*Revision updating drainage areas and inlet calculations and utility main alignments

CORLEY FARMS
UNIT 2

CONSTRUCTION PLANS

DRAIN PLAN & PROFILE - DRAIN '2-C'

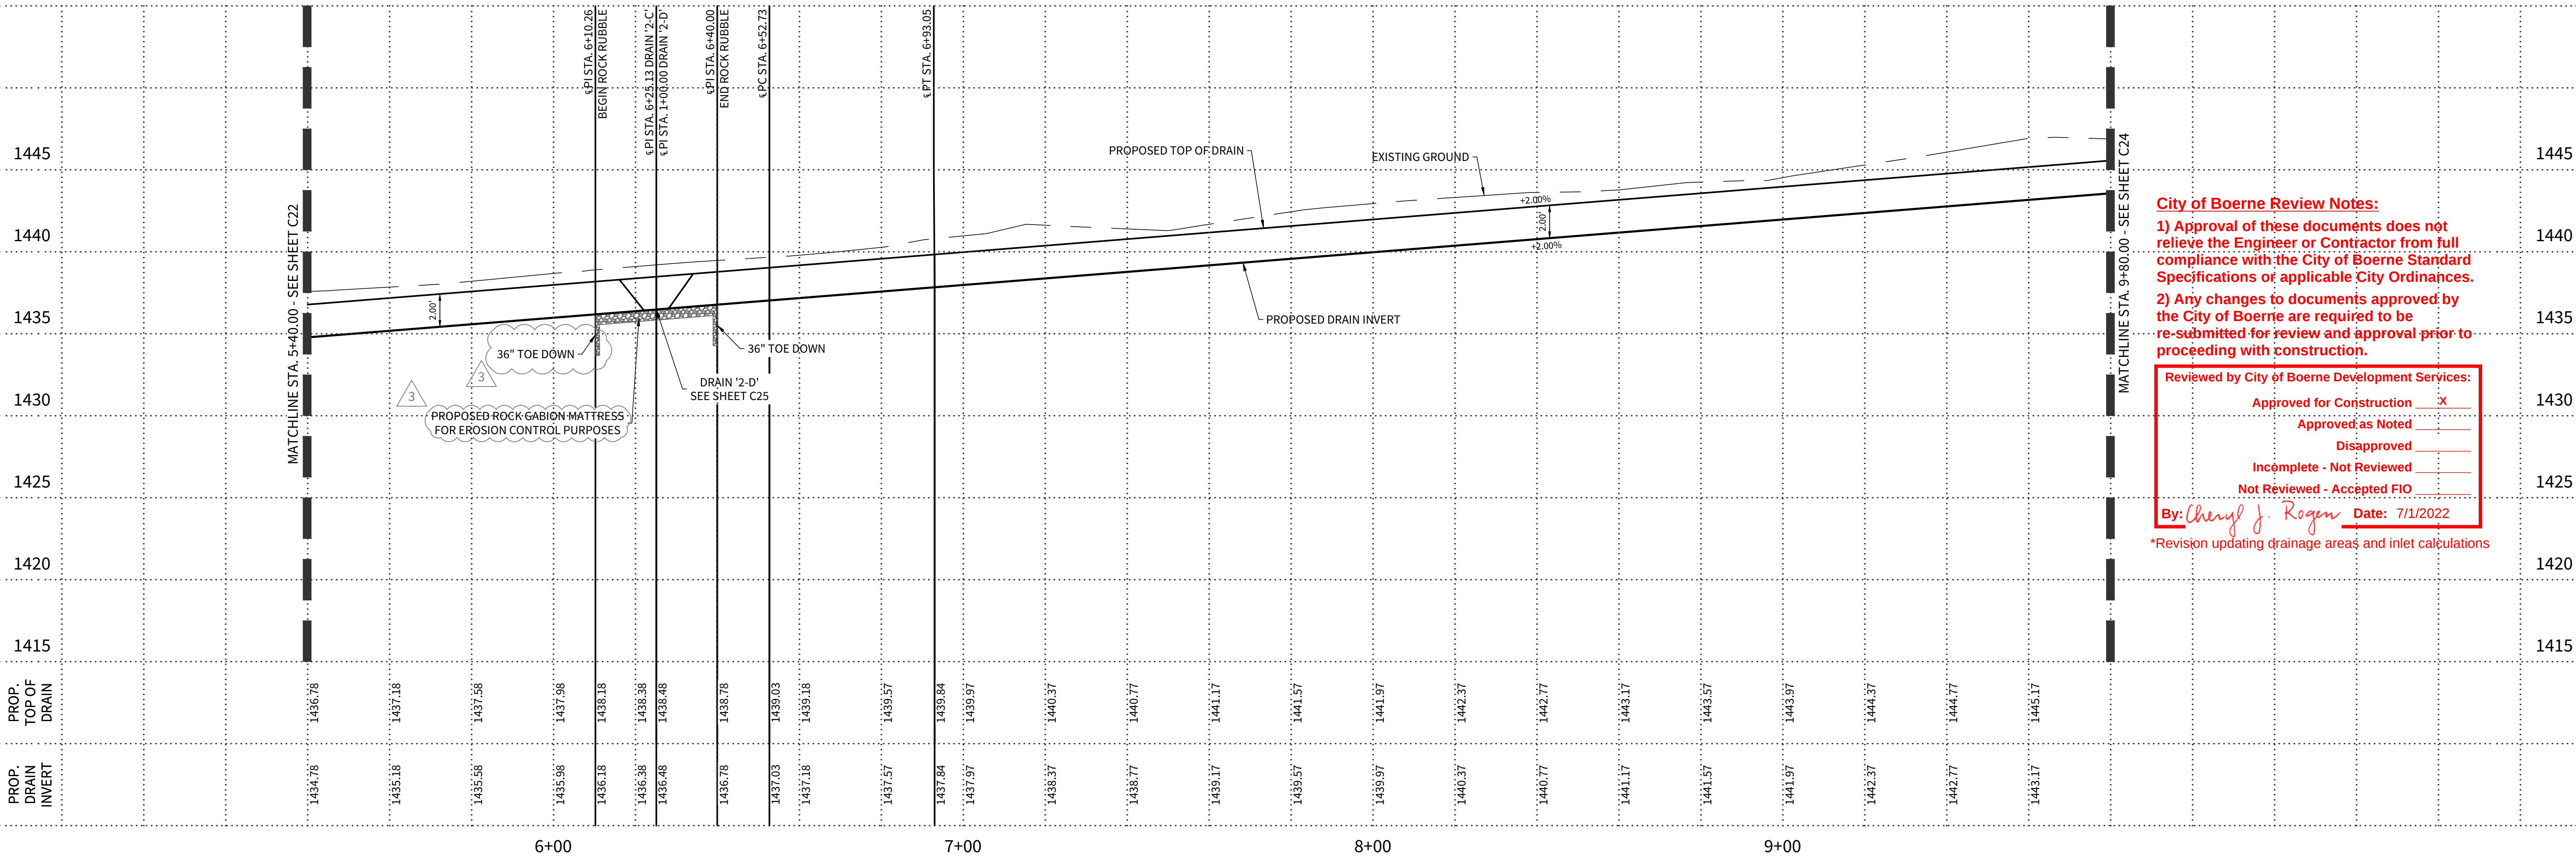
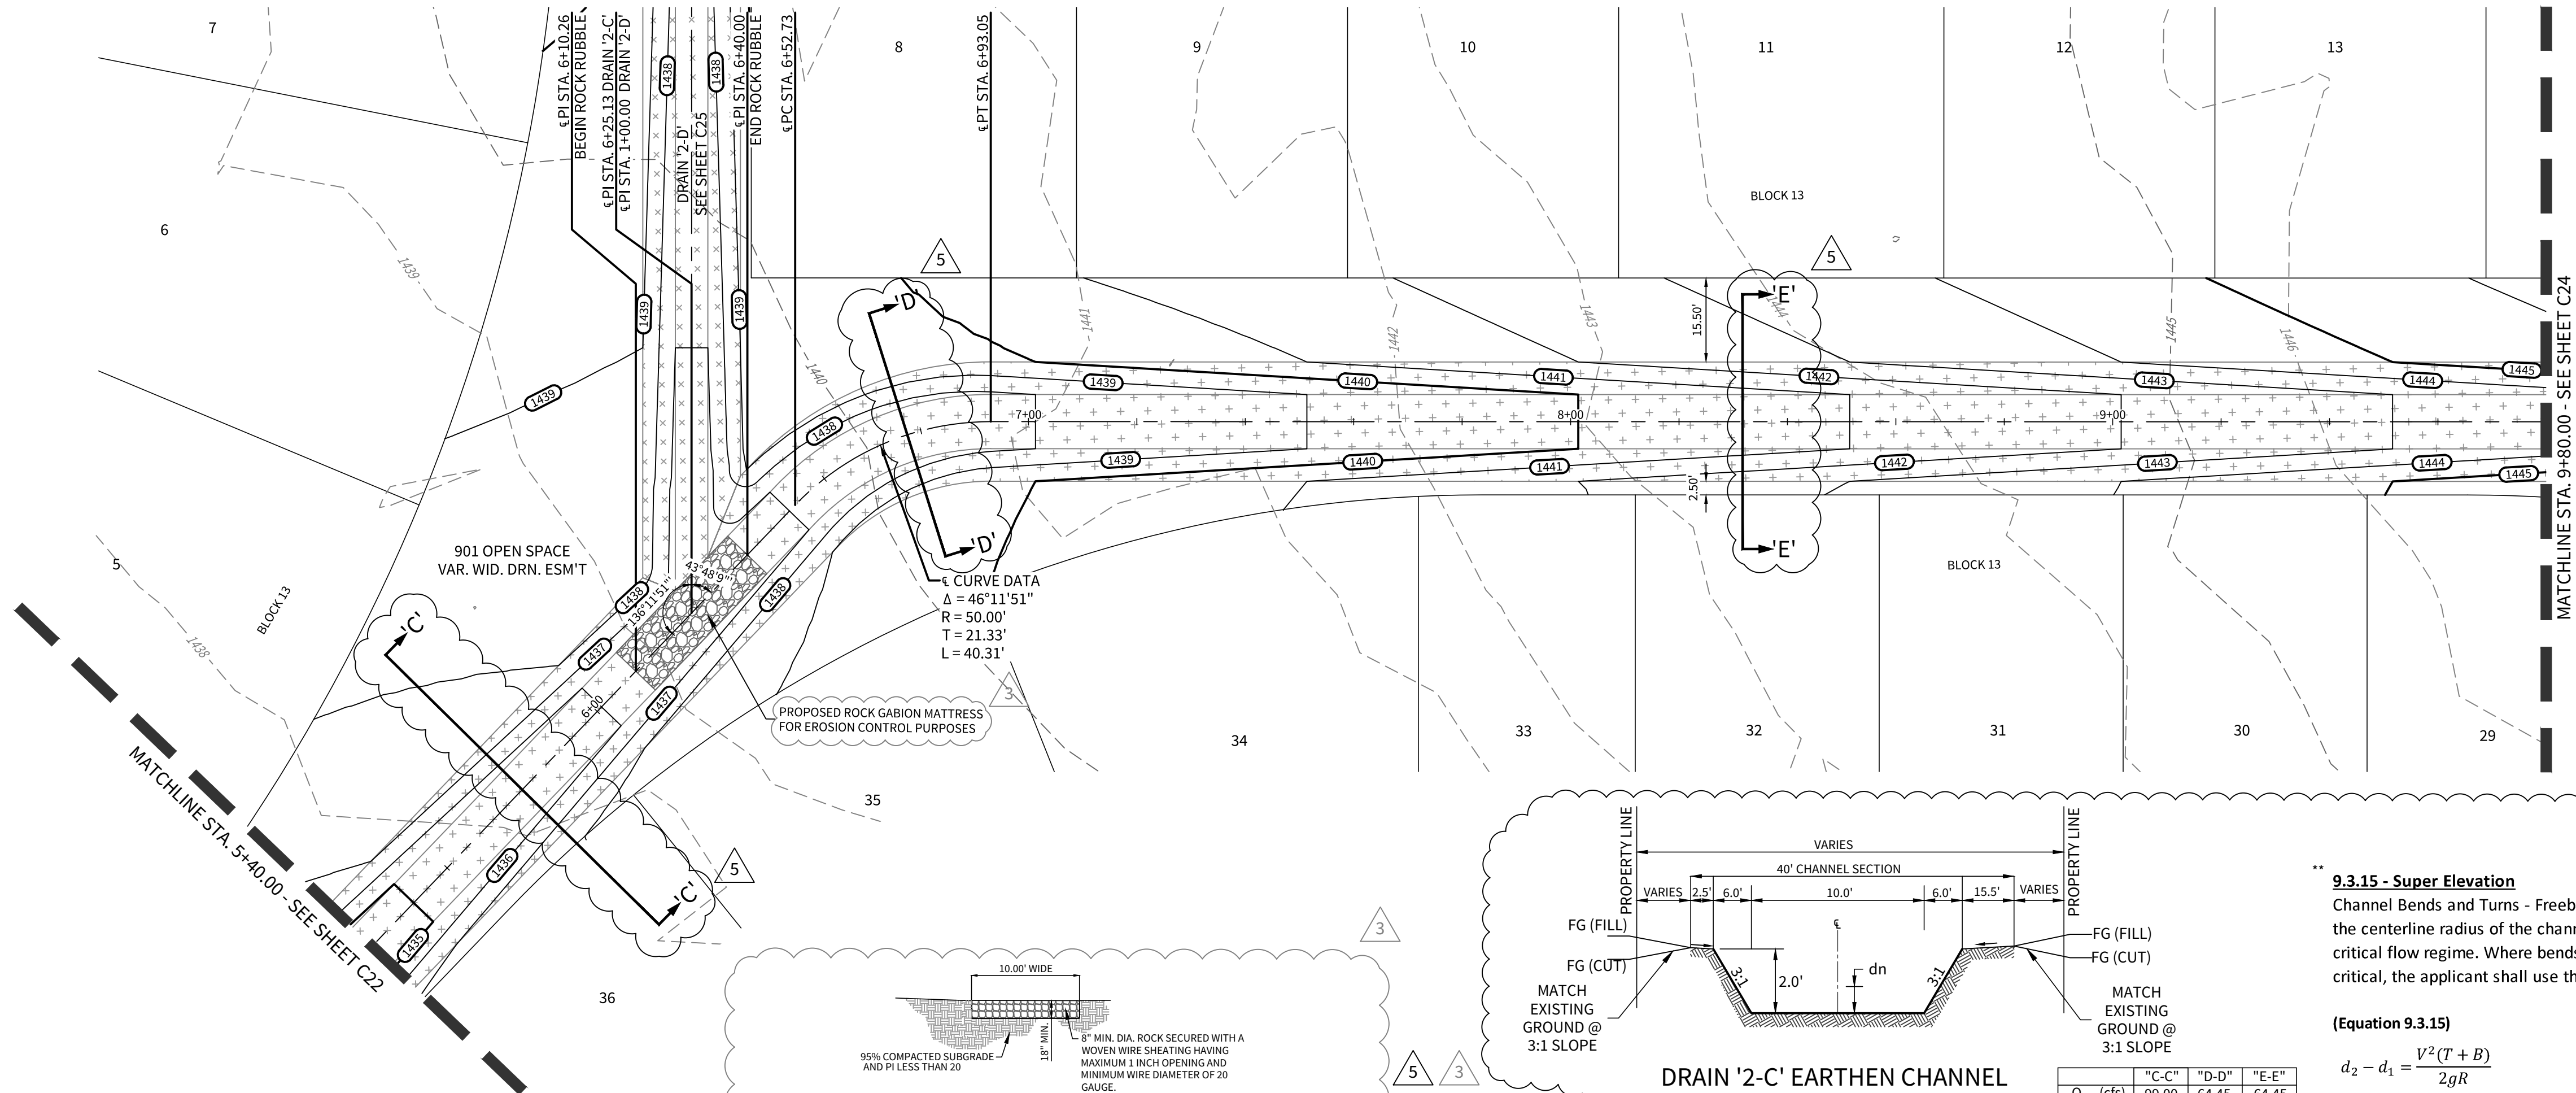
*Revision updating drainage areas and inlet calculations

- 1.
- 2.
3. 2021-10-07 - CITY OF BOERNE COMMENTS
4. 2021-11-12 - CITY OF BOERNE COMMENTS
5. 2022-03-03 - DRAINAGE UPDATES
- 6.
- 7.
- 8.
- 9.
